GENERAL MOTORS
DCS7143
URGENT - DISTRIBUTE IMMEDIATELY

Subject: N242489790 - Emission Recall
VECI Label Missing Required Information

Models: 2025 Chevrolet Silverado 1500
2025 Chevrolet Silverado 2500 HD/3500 HD
2025 GMC Sierra 1500
2025 GMC Sierra 2500 HD/3500 HD

N242489790 VECI Label Missing Required Information

6840549

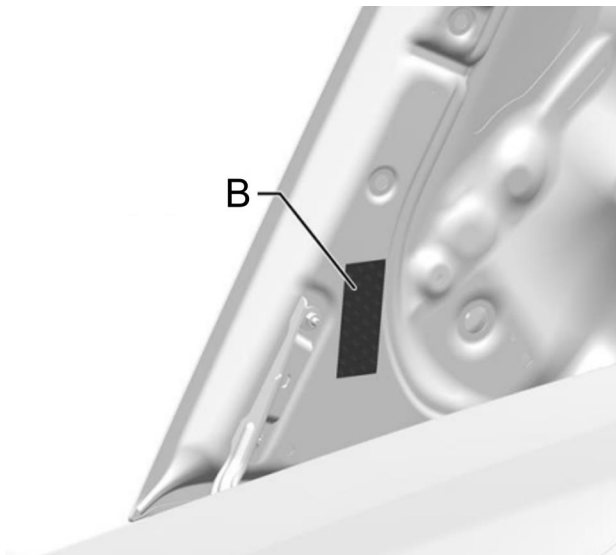
Condition	General Motors has decided to conduct a voluntary emissions recall. The Vehicle Emissions Control Information (VECI) label may not include all required information.
Correction	Dealers are to install a new VECI label.

Important: Do NOT place NEW label over existing label.

1. Remove the Vehicle Emission and Control Information (VECI) Label (A for LZ0-equipped vehicles, B for L5P/L8T-equipped vehicles) and any residue using isopropyl alcohol and dry with clean, lint free cloth. Receiving surface **MUST** be clean, dry and free of any contaminants.

2. Firmly hold the new label and peel protective liner from the back side, being careful not to touch or contaminate the adhesive with dirt or foreign matter.

3. Carefully align new label to the surface. Press firmly and smooth out entire label ensuring corners are fully adhered.
4. CALIFORNIA, COLORADO, CONNECTICUT, DELAWARE, MAINE, MARYLAND, MASSACHUSETTS, NEW JERSEY, NEW YORK, OREGON, RHODE ISLAND, VERMONT, WASHINGTON VEHICLES ONLY: Install a Recall Identification Label upon recall completion. See General Motors Service Policies and Procedures Manual, Recall Identification Label, for details.
